Addendum No. 5

Date: April 26, 2013

Reference: Regional Training Institute – TASS Phase 2
Utah National Guard – Camp Williams, Utah
DFCM Project No. 11020480

Subject: **Addendum No. 5**

C-001

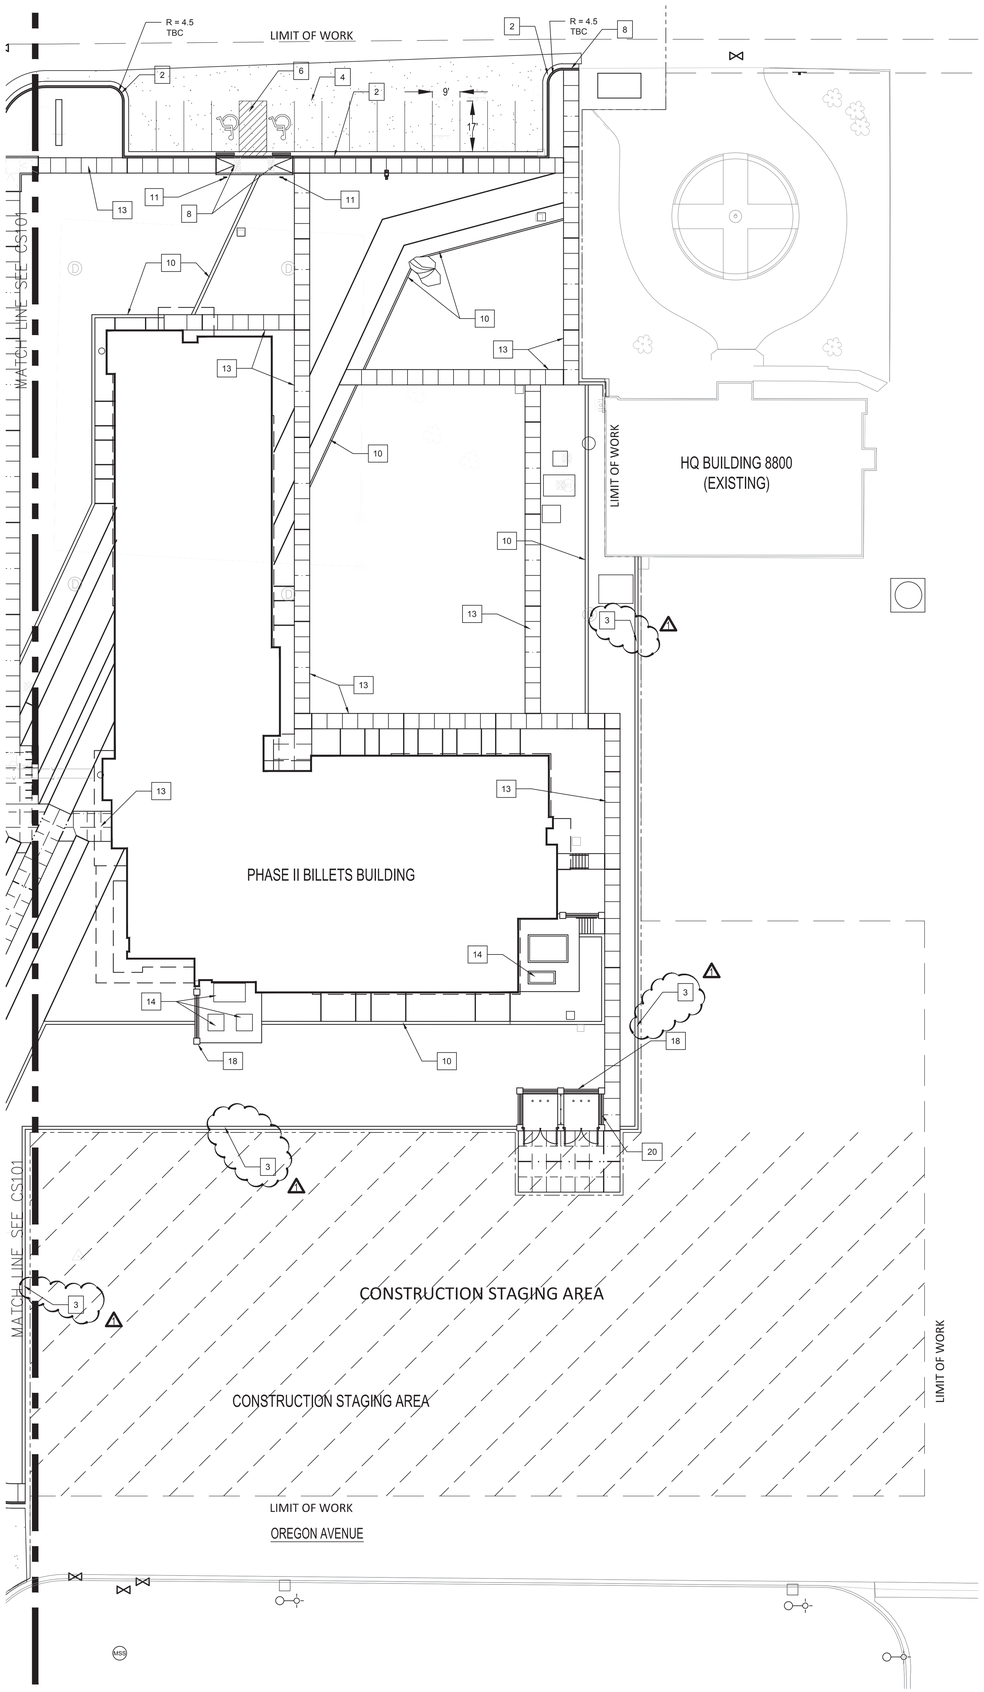
Item #	Sheet(s)	Amendment
A1.01	C-001	Changed note about owner paying for testing services
A1.02	CS102	Updated keynotes to reflect curb wall along western portion of site.
A1.03	CG102	Updated general note about sidewalk cracks and repairs. Updated spot elevations for curb wall along western portion of site.
A1.04	CU102	Updated the Grease Interceptors to be two separate smaller units. Updated a sanitary sewer manhole on the south of the Admin building to include a drop structure
A1.05	CU503	Added South Valley Sewer Grease Interceptor, Sampling Manhole, and Drop Manhole Details.

B2 SF101 ADDITIVE / ALTERNATE MAIN LEVEL FLOOR FRAMING PLAN
SCALE: 1/8" = 1'-0"

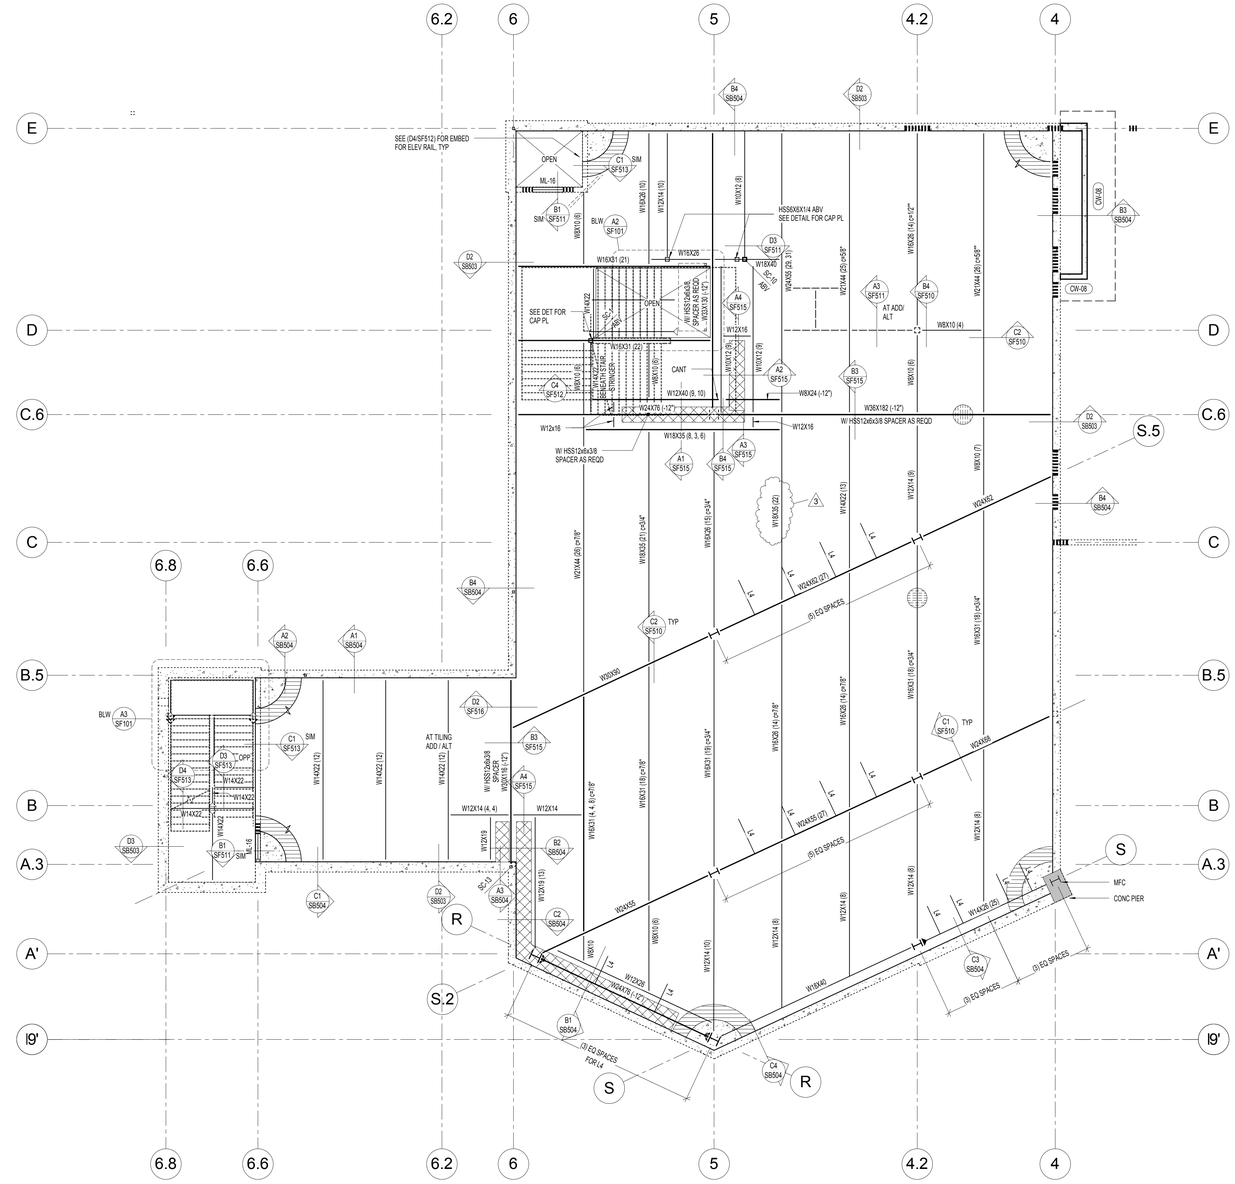
1. Drawing SF101 – Revised floor beam from W16x26 to W18x35.
2. Drawing SF102 – Revised (5) W10x12 floor beams to W10x15's.

1 OVERALL ELECTRICAL SITE PLAN POWER
ES100 1" = 30'-0"

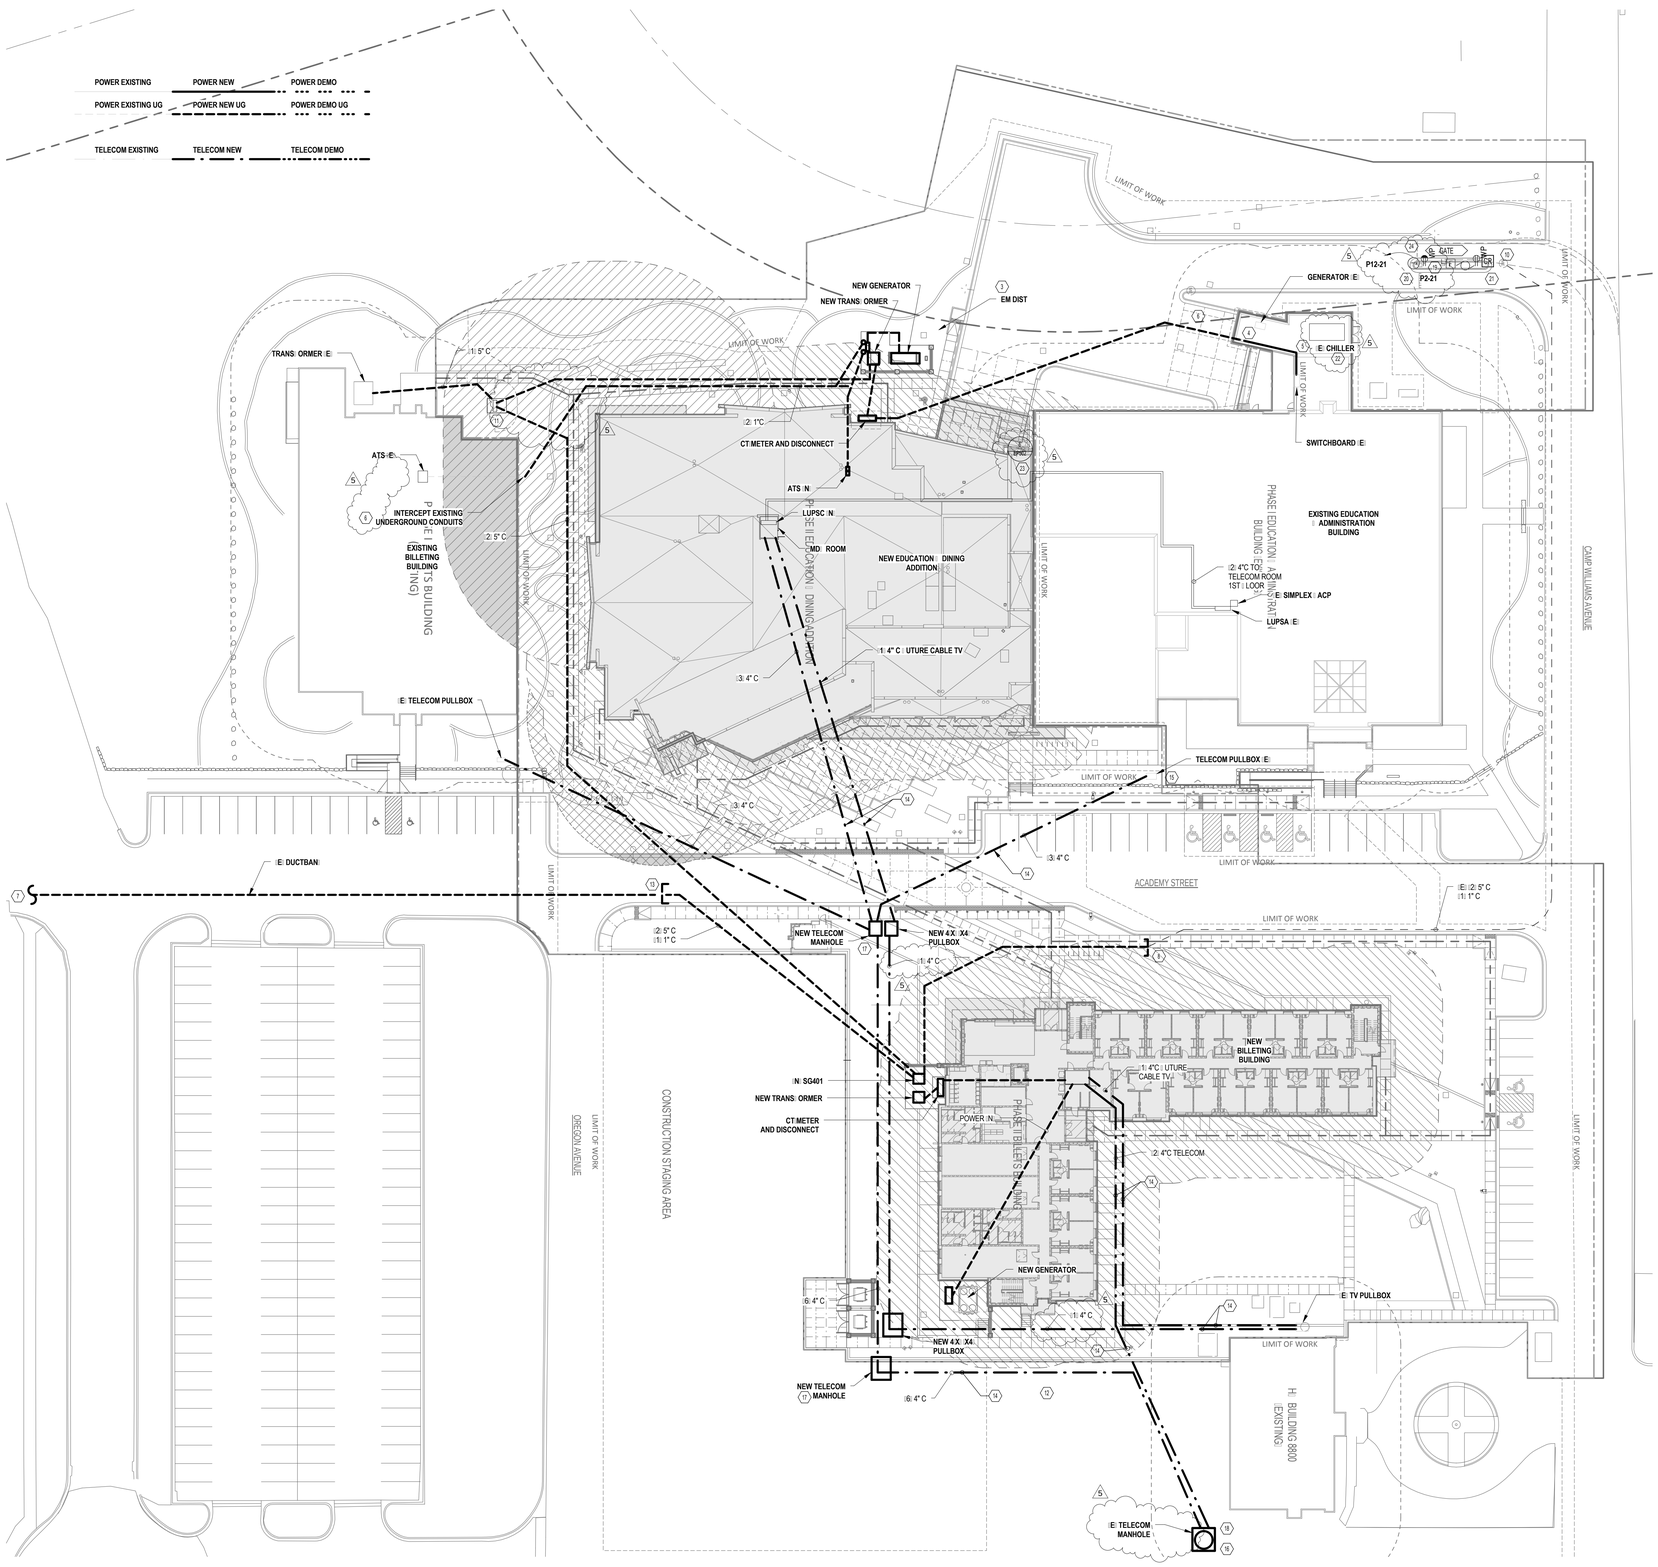
26. Sheet ES100: The communication manhole adjacent to HQ building 8800 has conflicting notes, the description states "new manhole" sheet note 18 states "existing"
    a. ***See the attached Memorandum from Engineer, dated April 25, 2013.***

27. Sheet ES100: TV conduits - (E) TV pull box to the two new pull boxes. How many conduits? What size? Concrete cap?
    a. ***See the attached Memorandum from Engineer, dated April 25, 2013.***

28. Sheet ES100: Identify circuits at gate and size of disconnect? Is note 19 applicable?
    a. ***See the attached Memorandum from Engineer, dated April 25, 2013.***

29. Sheet ES100: Note 12, south of HQ seems to be out of place or misrepresented please clarify.
    a. ***See the attached Memorandum from Engineer, dated April 25, 2013.***

30. Sheet ES100: Note 9 not used.
    a. ***See the attached Memorandum from Engineer, dated April 25, 2013.***

31. Sheet ES100: Note 20 not used, what are the requirements to existing system, etc.?
    a. ***See the attached Memorandum from Engineer, dated April 25, 2013.***

32. Sheet ES100: Note 6 shown by ATS (E) in the existing billets building, unsure of application
    a. ***See the attached Memorandum from Engineer, dated April 25, 2013.***

4. *Note 12, south of HQ seems to be out of place or misrepresented please clarify.*
   KGE RESPONSE. If you look at sheet ED100, you will see where the existing ductbank used to be.

1 ELECTRICAL SITE PLAN LIGHTING
ES101 1" = 30'-0"

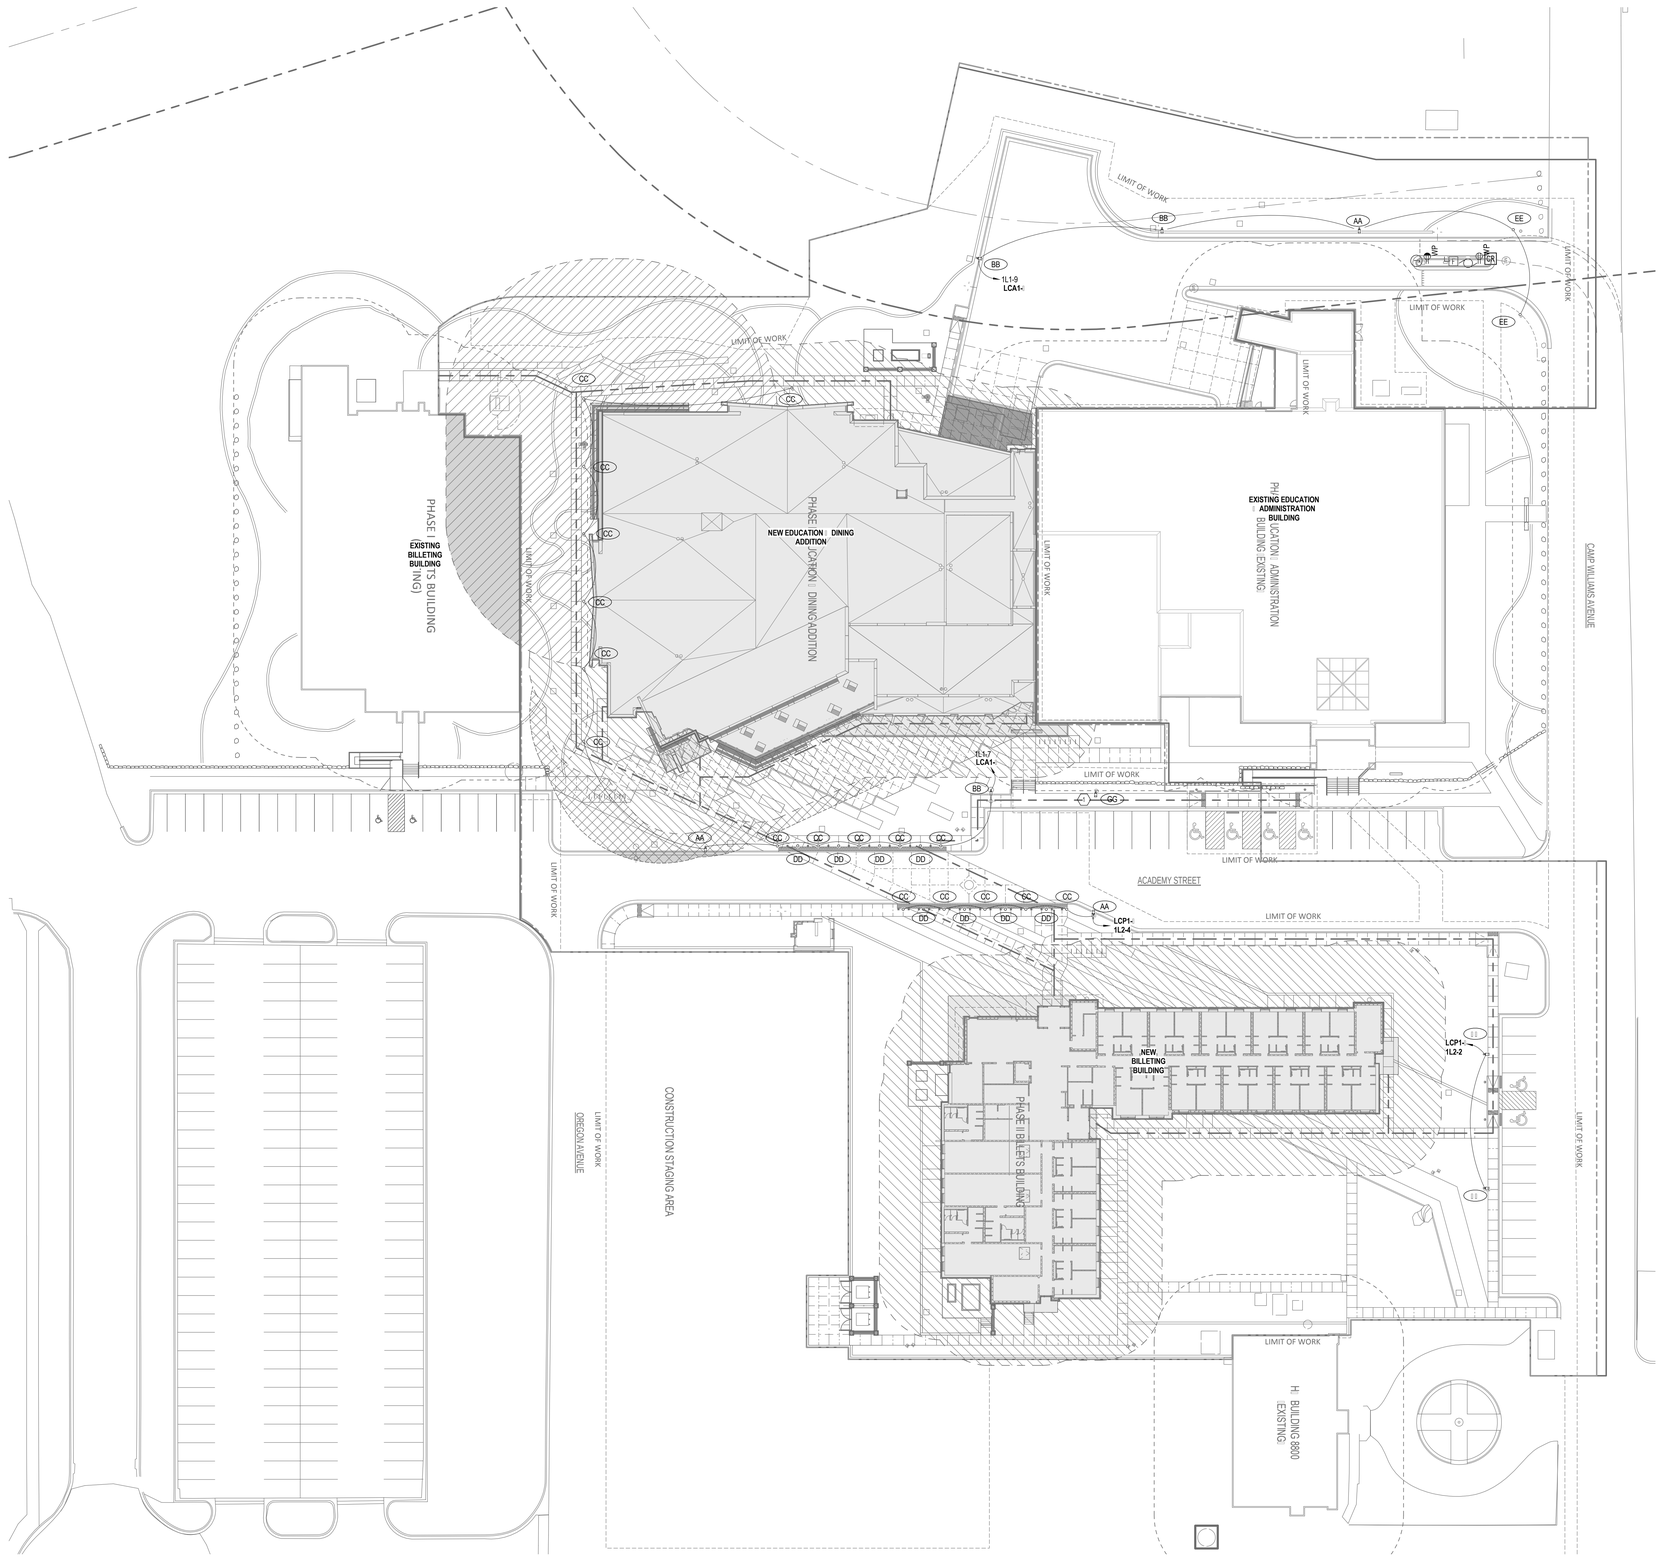
33. Sheet ES101: Reference note 1, no description shows adjacent to pole GG.
    a. ***See the attached Memorandum from Engineer, dated April 25, 2013.***
